Seneca Army Depot Activity
Romulus, NY

Ordnance and Explosives
Engineering Evaluation
Cost Analysis Report

SUBJECT: Submittal of the Final Ordnance and Explosive Engineering Evaluation / Cost Analysis Report, Seneca Army Depot, Romulus, Seneca County, New York.

This Final OE EE/CA includes revisions in response to EPA comments dated February 21, 2003. The response to comments was previously submitted.

DESIGNED BY: JEB	Figure 3.25 OE Items Recovered in SEAD-46 (3.5" Rocket Range)		
DRAWN BY: JEB	SCALE: 1:1800	PROJECT NUMBER: 736703-01000	
CHECKED BY: BJM	DATE: JAN 2004	PAGE NUMBER:	Figure 3.25
SUBMITTED BY: SAS	FILE: SEAD_46.APR

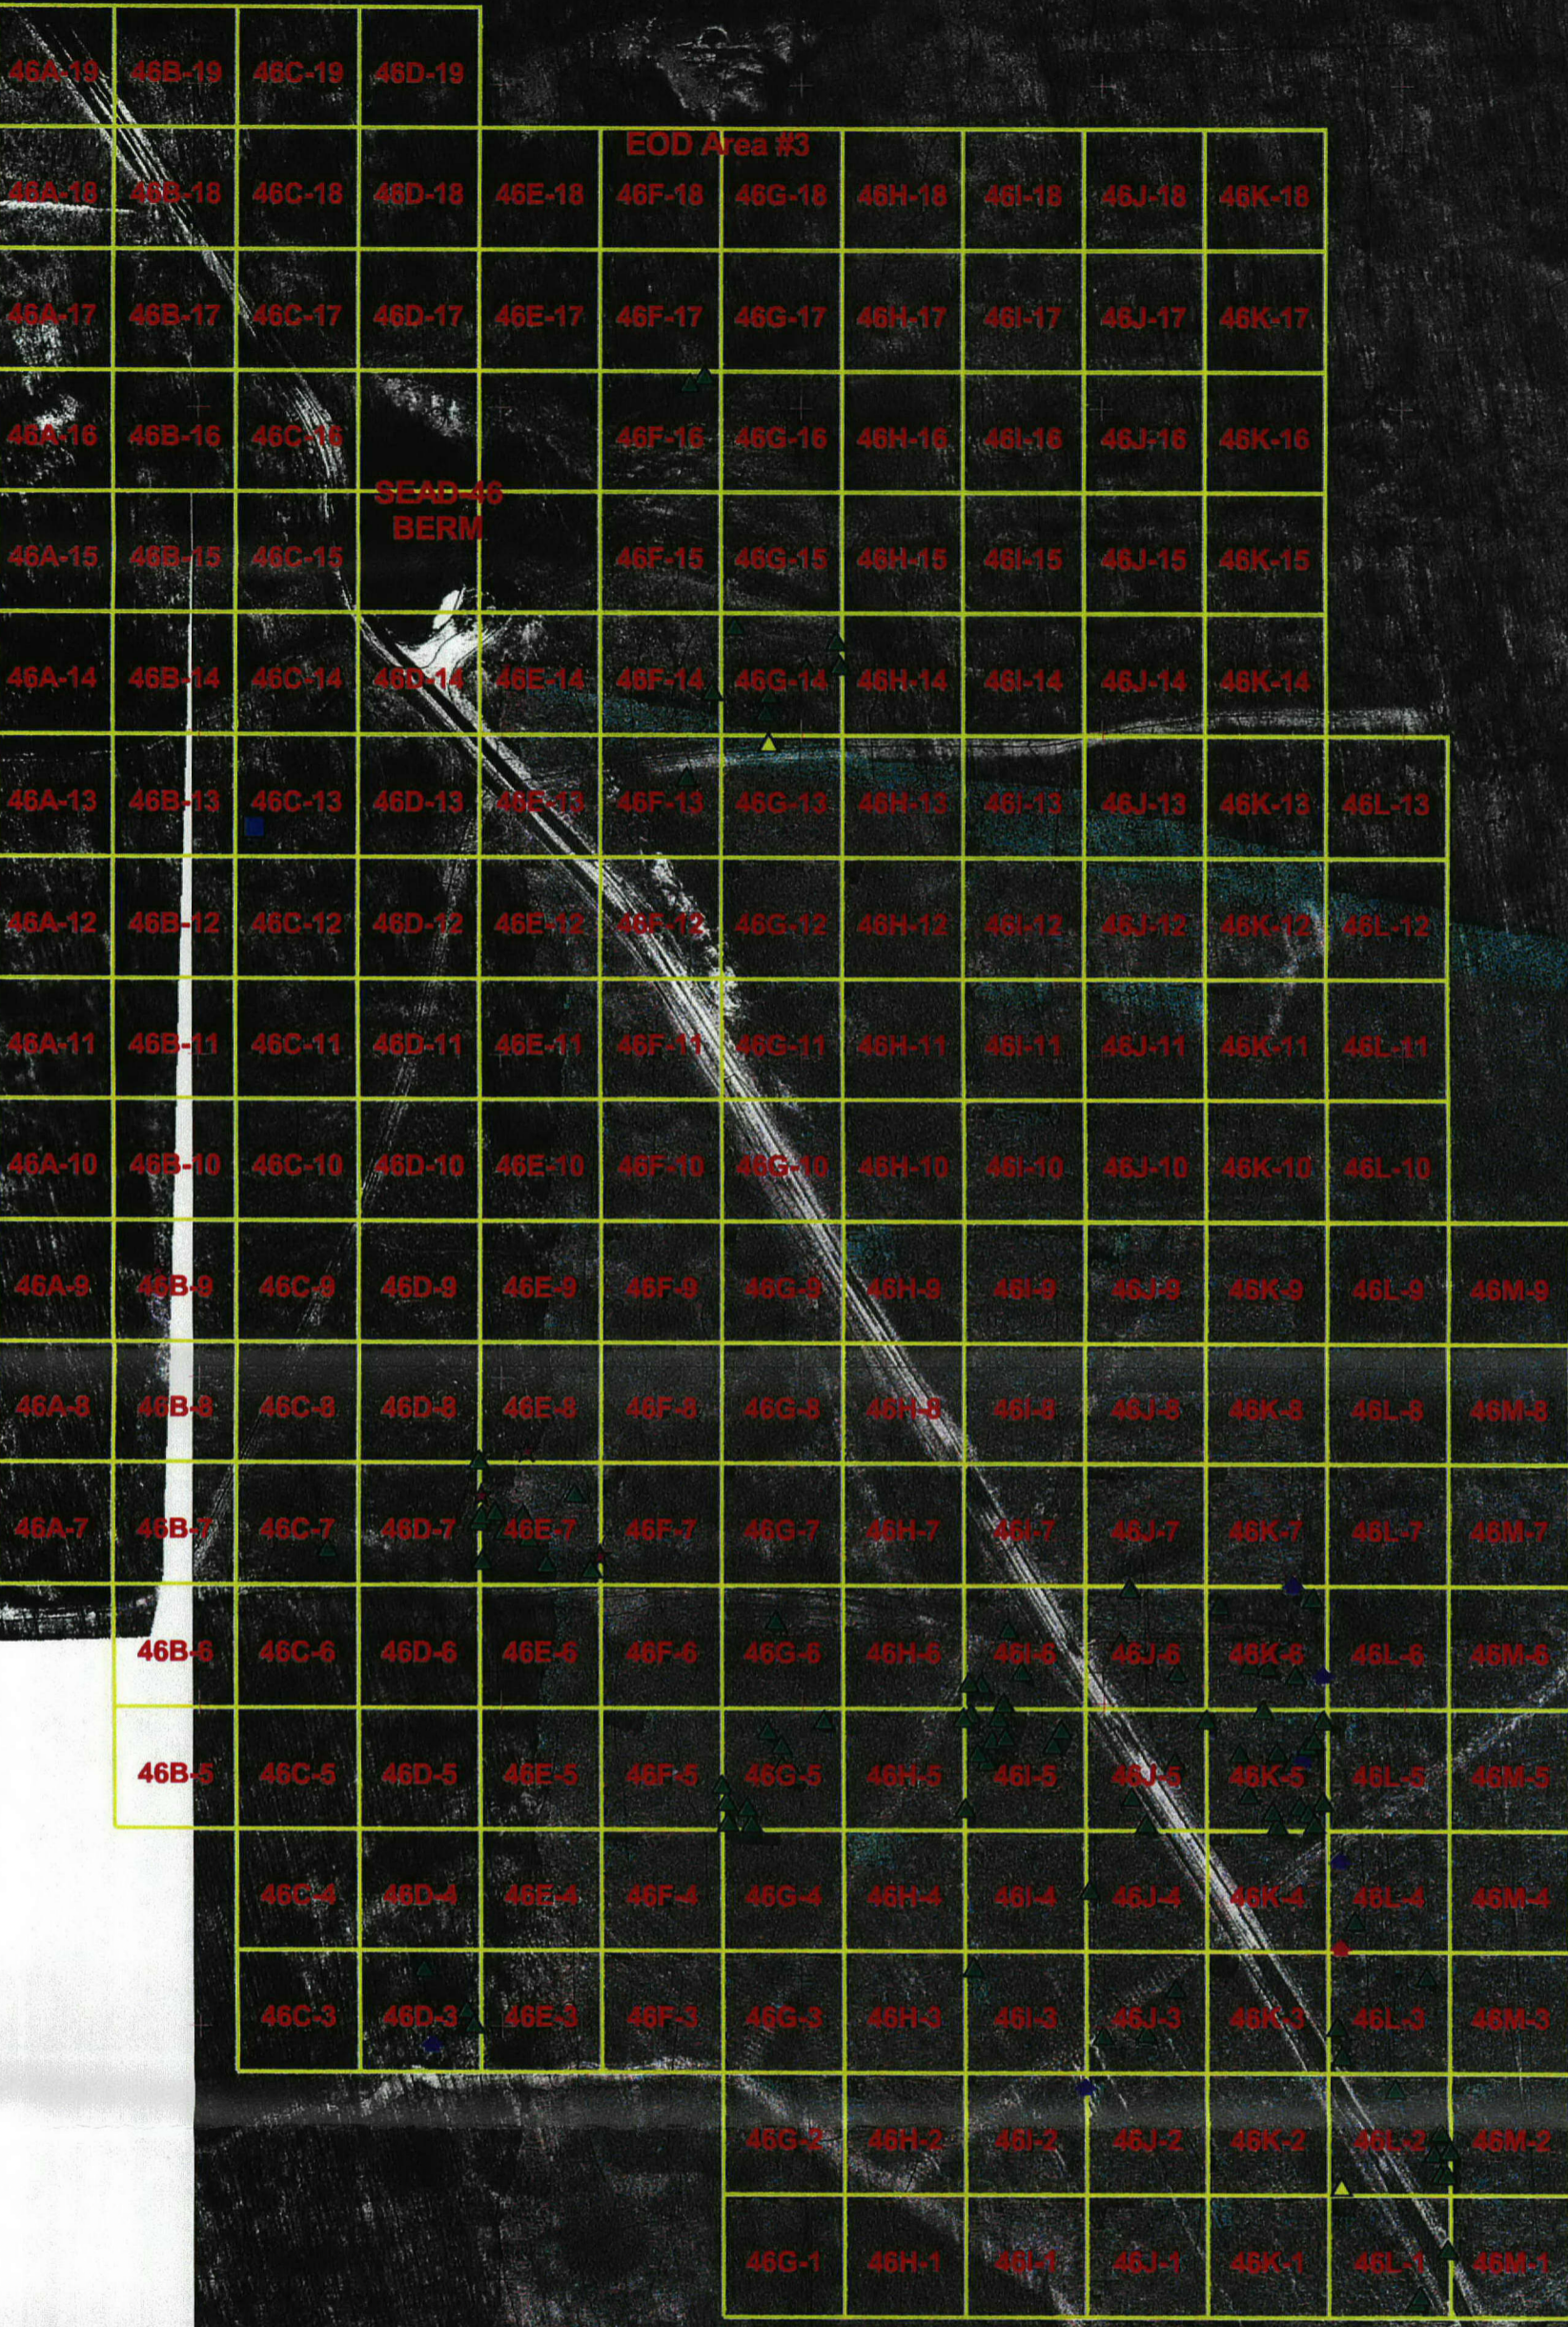
23.	Figure 3.24, et al	Please identify the significance of the yellow dot with crosshairs in the middle in the legend. If, as appears to be the case, these are the OE items shown in Figure 3.25, recommend that the yellow dots be removed from Figure 3.24 as this drawing is supposed to show the UXO that was found.	A: These were the OE recovered in SEAD-46 and have been removed.
